SUBDIVISION REVIEW SHEET

CASE NO.: C8-2018-0165.2A **Z.A.P. DATE:** December 8, 2020

SUBDIVISION NAME: Cascades at Onion Creek East, Phase Two

CITY OF AUSTIN -DEVELOPMENT SERVICES DEPARTMENT SUBDIVISION APPLICATION - MASTER COMMENT REPORT

CAPITAL
7				SURVEYING
				COMPANY
				INCORPORATE
125 Capital of Texas Building B, Suite 11 Austin, Texas 78746 512) 327—4006	5			FIRM REGISTRATION No. 101267-0
DRAWN BY:	WAL	SCALE:	N/A	F.B.
JOB NO.:	19518.10	DATE: SEF	TEMBER 28, 2020	
DRAWING NO.:	19518p1	CRD #:	17534	1 OF 4

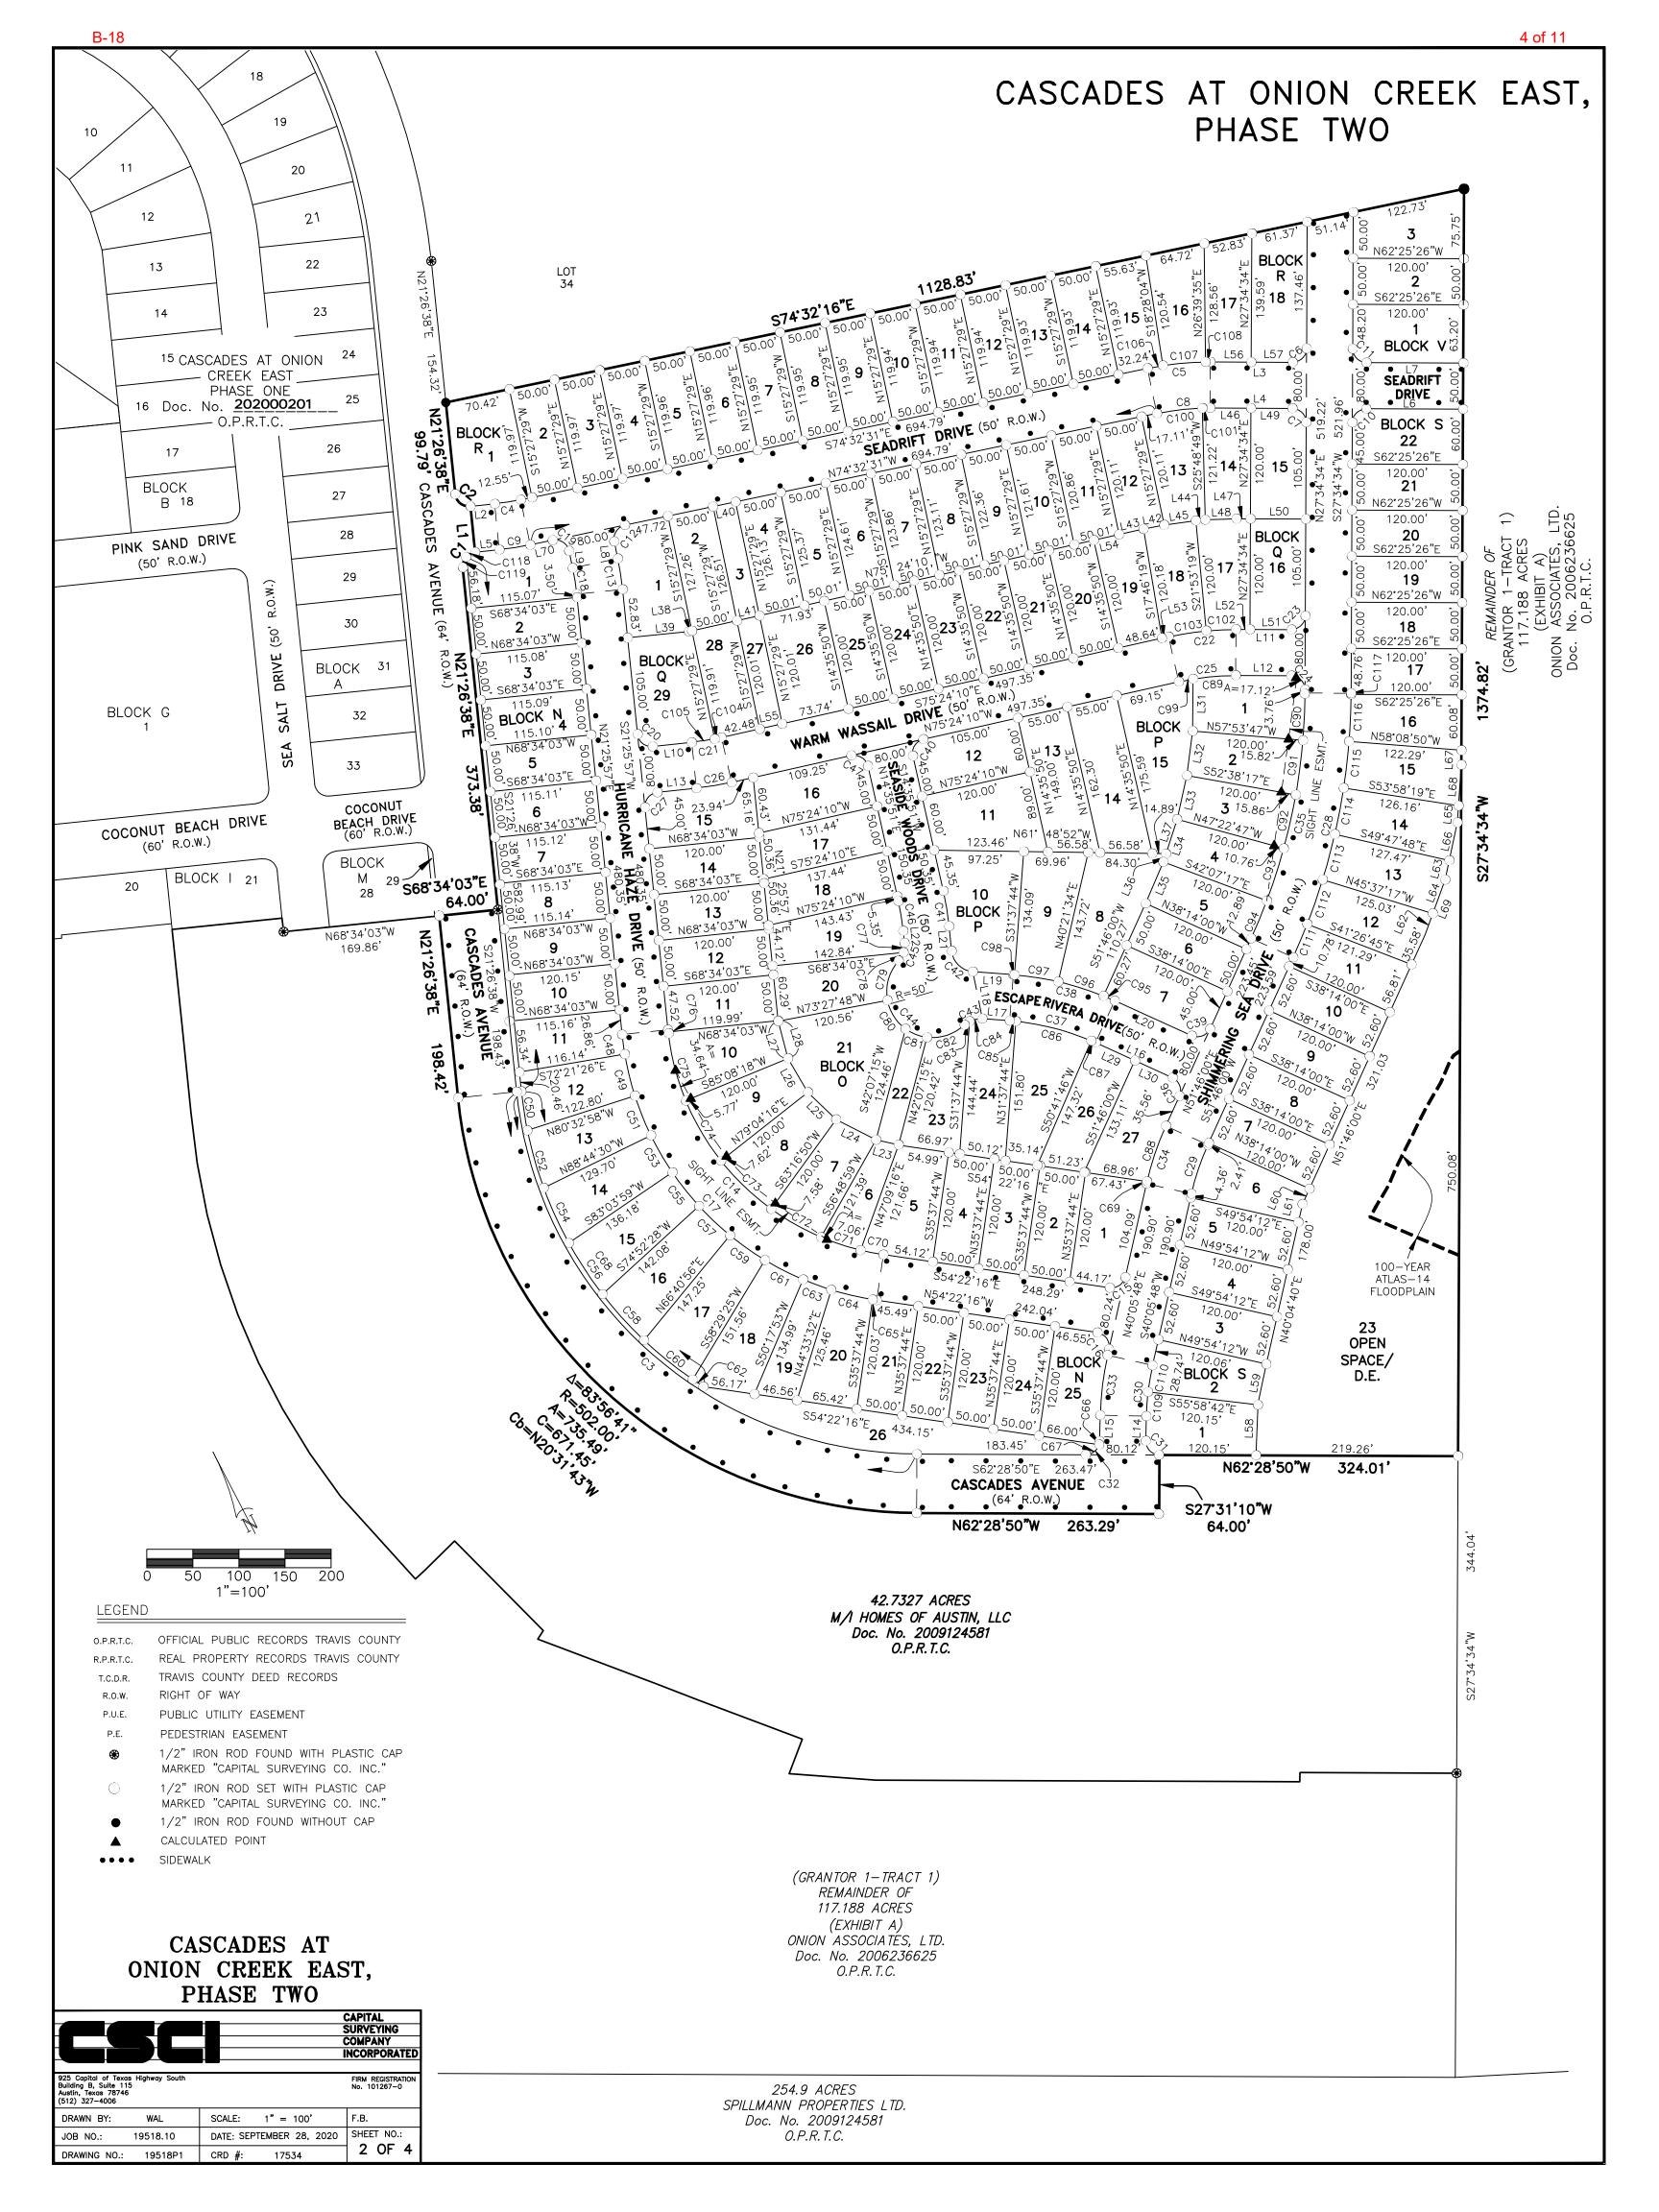
In addition to the 10' electric distribution, electric telecommunications, and electric fiber easements dedicated along all ROW, a 15' ETE is required adjacent to **Cascades Avenue**. Show the easements on the face of the plat

SR 1. Update the director's approval block to show the case manager's name below the signature line, (L.D.C. 25-1-83):

- SR 2. Show the application submittal date on the plat, November 9, 2020. (L.D.C 25-1-83)
- SR 3. Include the case number on the lower right corner of each plat sheet, C8-2018-0165.2A . (L.D.C 25-1-83)
- SR 4. Verify that the lots meet SF-2 lot requirements to avoid amendments to the plat during the Residential Permitting phase. Lots for residential development should have minimum lot size of 5,750 square feet and have a minimum lot width of 50 feet. to avoid any future amendments to the plat. (L.D.C. 25-2-492)
- SR 5. On Sheet 3 of the plat in Note # 26, include the document number for the H.O.A. document.

- TR1. The ROW identified in Note 22 of the final plat does not match the street names shown on the face of the plat. Please revise.
- TR2. Prior to the recording of any final plat, fiscal surety is required for sidewalks along open space lots for the streets notes in the Preliminary plat. This would include Block N Lot 26 along Cascades Avenue.

Remove note 23 from the plat. There are no existing easements within the boundaries of the proposed plat.
